**TOWN OF OCEAN RIDGE
PLANNING & ZONING REGULAR MEETING
AGENDA**

Town of Ocean Ridge, Florida
Planning & Zoning Board Agenda Memorandum

To:	Planning & Zoning Board Members
From:	Corey O’Gorman, Town Planner
Meeting Date:	December 16, 2025
Subject:	25 Sabal Island Dr – Development Plan Review

PLAN REVIEW CRITIQUE
25 Sabal Island Drive
07/11/25 / 10/15/25

A101

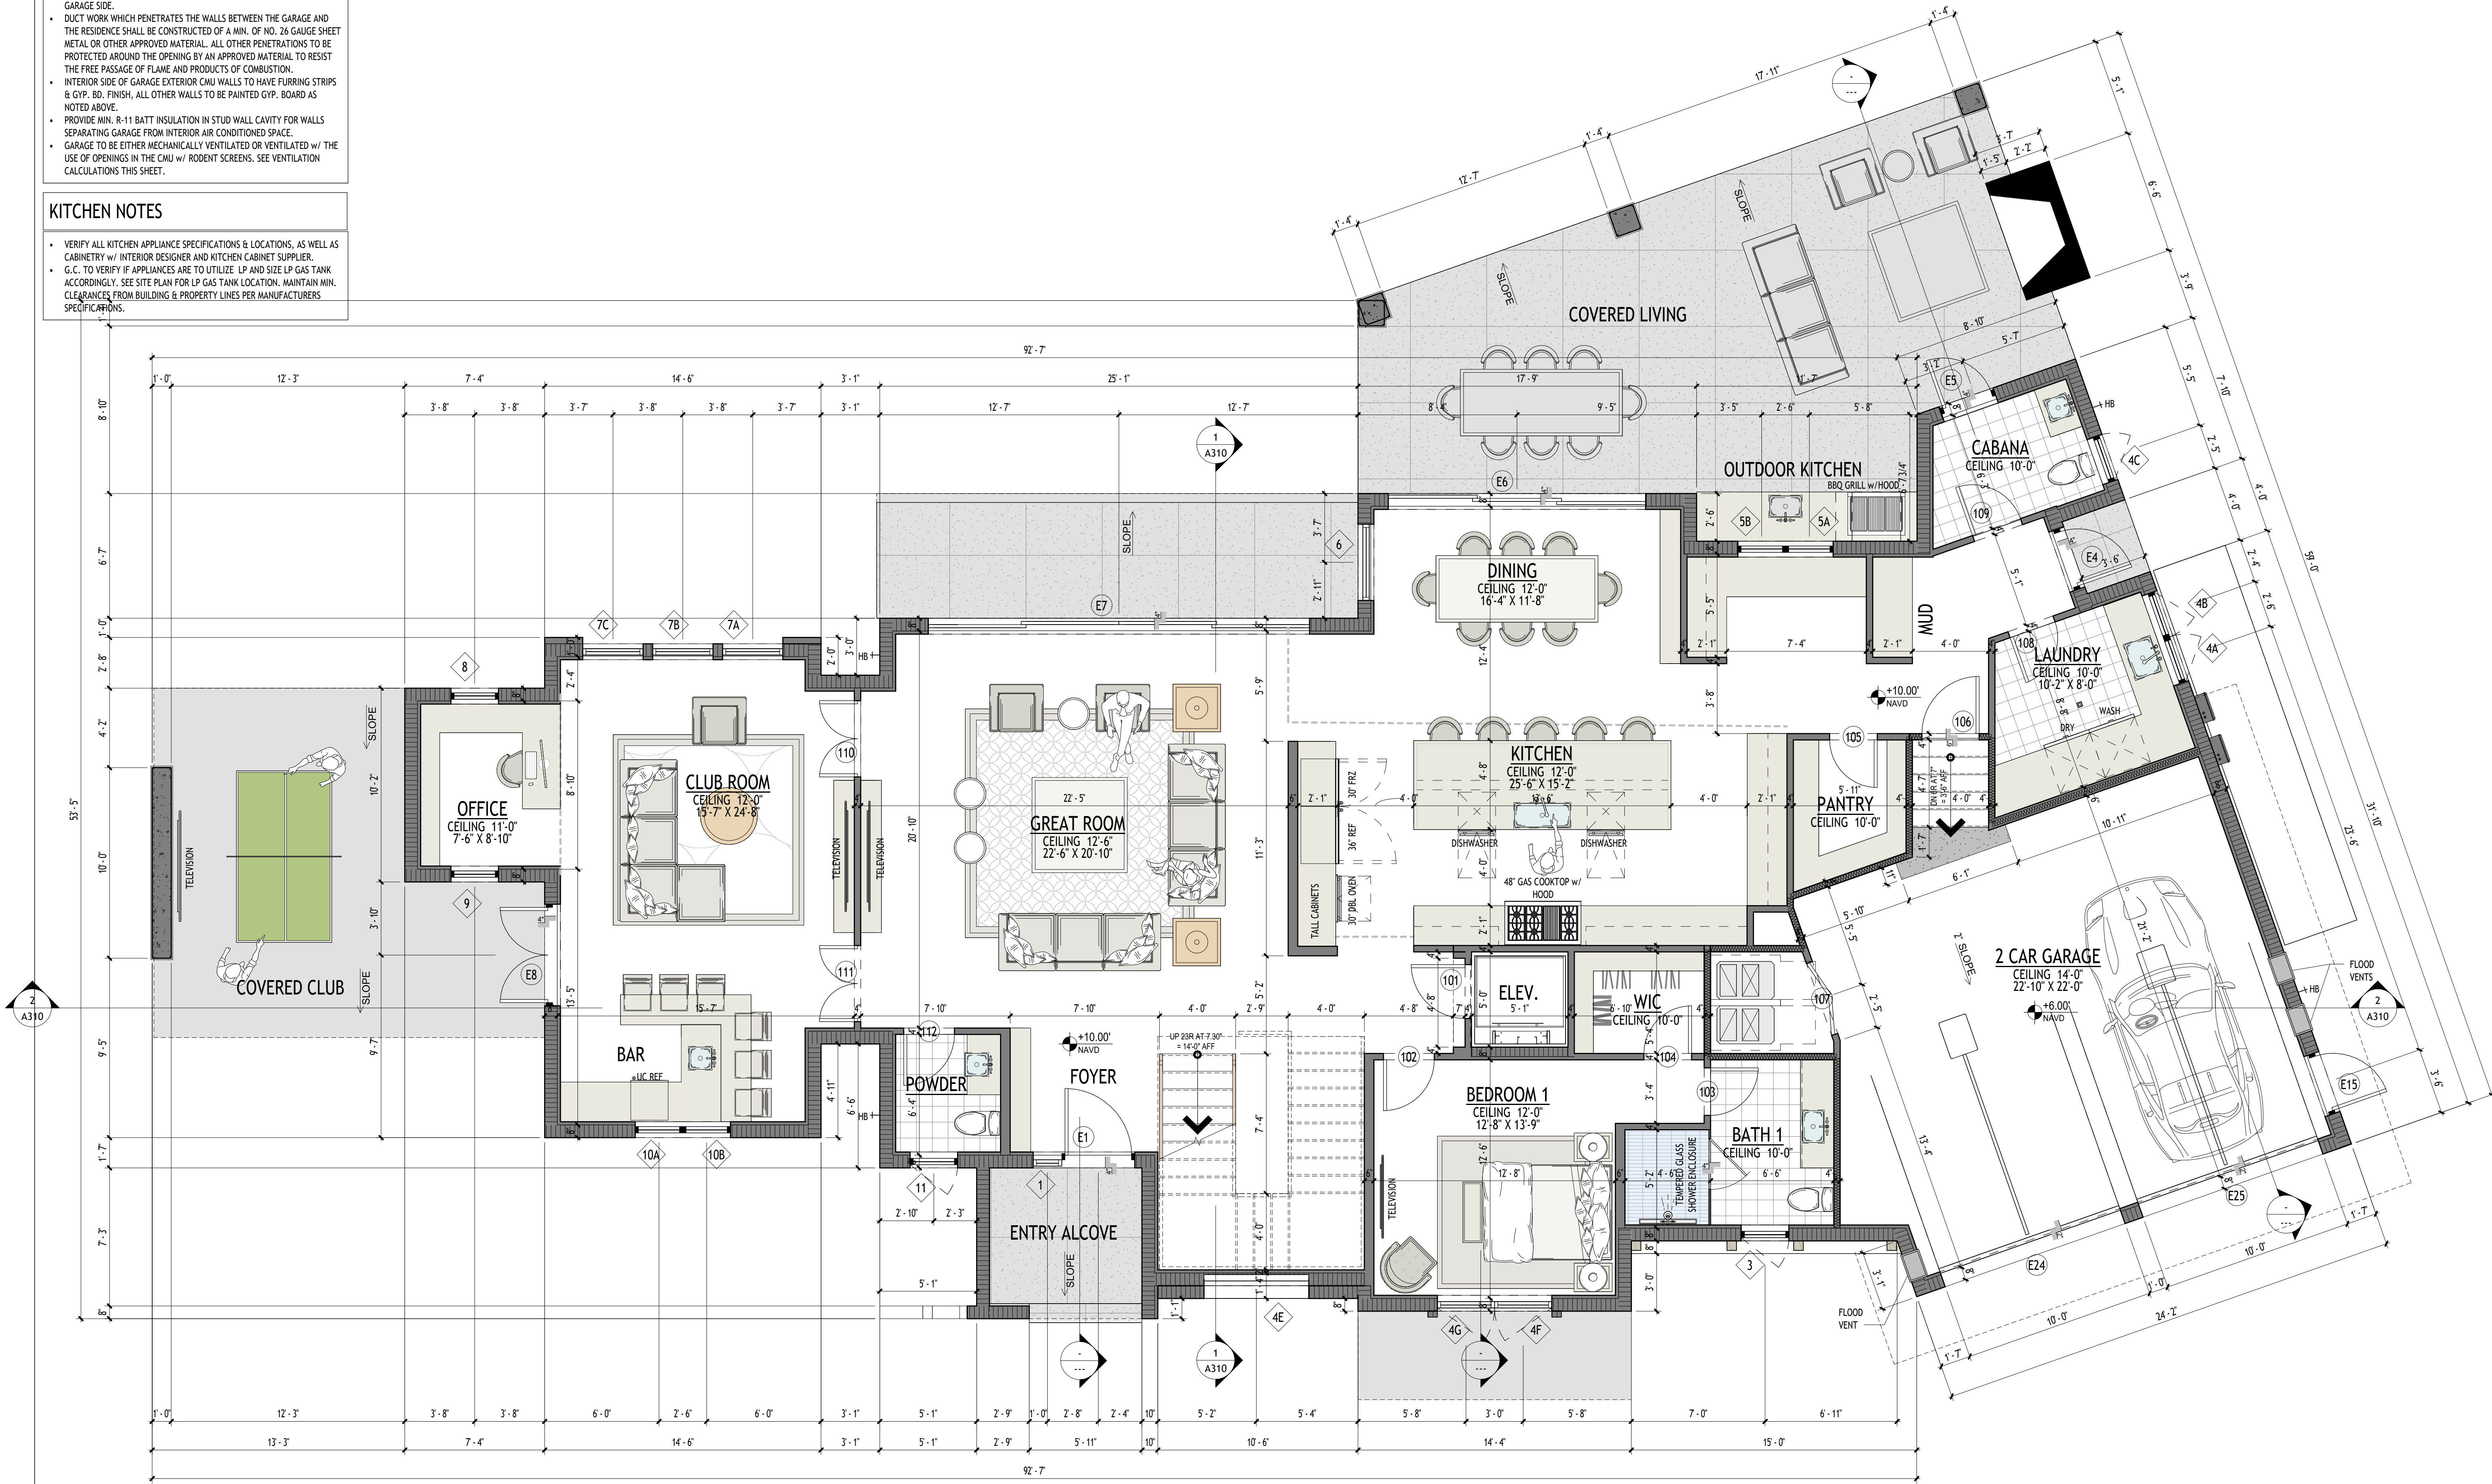
Section 64-42 (b) — **Background:** This code section requires a 5' setback for the swimming pool from property lines and 5' distance to the primary building, but no setbacks are specified. Also, the plans appear to show a "sand" area next to the swimming pool, but it is not clear if that is correct.

Comment: Please revise sheet A101 to indicate the distances from the pool to both the primary building and the property line, and please clarify if the "sand" area is proposed. **COMMENT ADDRESSED**

Section 64-44 — **Background:** This code section specifies the maximum fence and wall height and allows 4' in the front yard (which includes roadway frontages and canal / waterway frontages) and 6' in the side. And if the fence/wall are located on a retaining wall, the height of the retaining wall is included. The plans appear to show both a retaining wall and a fence/wall, but it is not entirely clear.

Comment: Please revise Sheet A101 to clearly show the location and height of any fences/walls as required. **COMMENT ADDRESSED**

Section 64-46 — **Background:** This code section requires that one parking space must be provided per bedroom or room that may qualify as a bedroom, and every single family home shall include a garage designed to accommodate two (2) full size vehicles with spaces dimensioned at 10' X 20'. Sheet A-101 shows garage spaces although they are dimensioned at 10' x 18'.

Comment: Please revise the plans to ensure that the interior garage spaces are 10' x 20' of unobstructed area. **COMMENT ADDRESSED**
